DEPARTMENT OF TRANSPORTATION
National Highway Traffic Safety Administration
Docket No. NHTSA-2010-0053
Visual-Manual NHTSA Driver Distraction Guidelines
For In-Vehicle Electronic Devices

ACTION: Notice of Federal guidelines.

This notice announces the issuance of the final version of the first phase of the NHTSA Guidelines. This first phase applies to original equipment (OE) in-vehicle electronic devices used by the driver to perform secondary tasks (communications, entertainment, information gathering, navigation tasks, etc. are considered secondary tasks) through visual-manual means (i.e., the driver looks at a device, manipulates a device-related control with his or her hand, and/or watches for visual feedback).

Figure 2: Drawing of Slide Presented by Toyota at NHTSA Technical Workshop¹³⁶

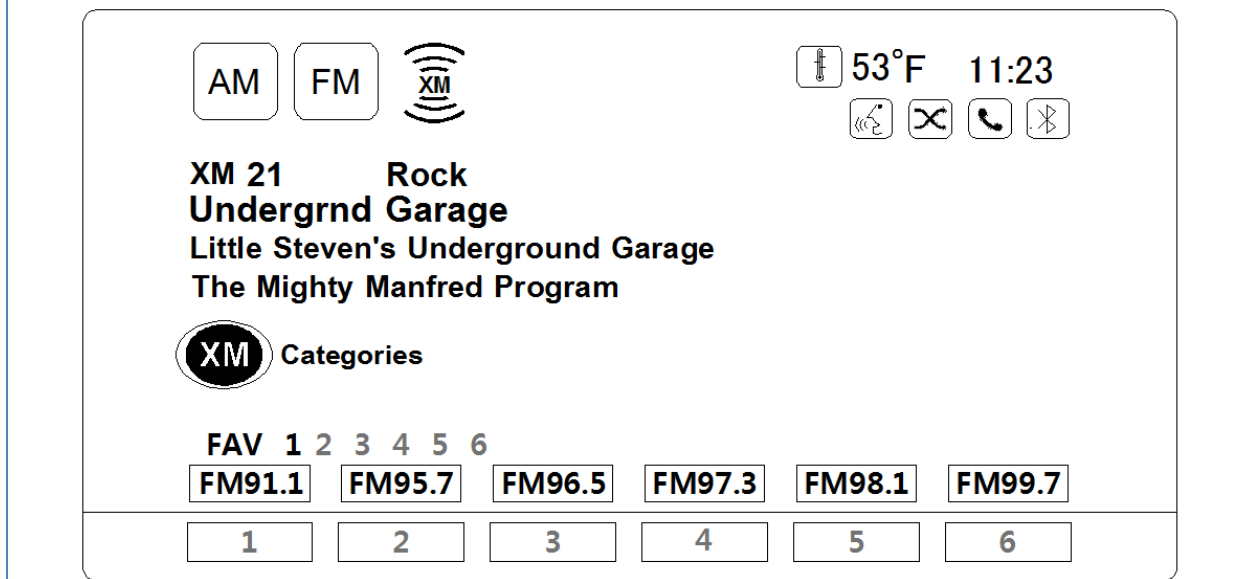
During the March 23, 2012 Technical Workshop on NHTSA's proposed Driver Distraction Guidelines, Mr. James Foley of Toyota showed a slide picturing a contemporary radio display showing several lines of text indicating satellite radio station program information (See Figure 2 below). He then asked:

Where should the 30 character limit be applied to this display?

Mr. Foley then pointed out that the information conveyed by this display is easily grasped and that drivers do not have to read each individual letter to understand what is being transmitted by this display.
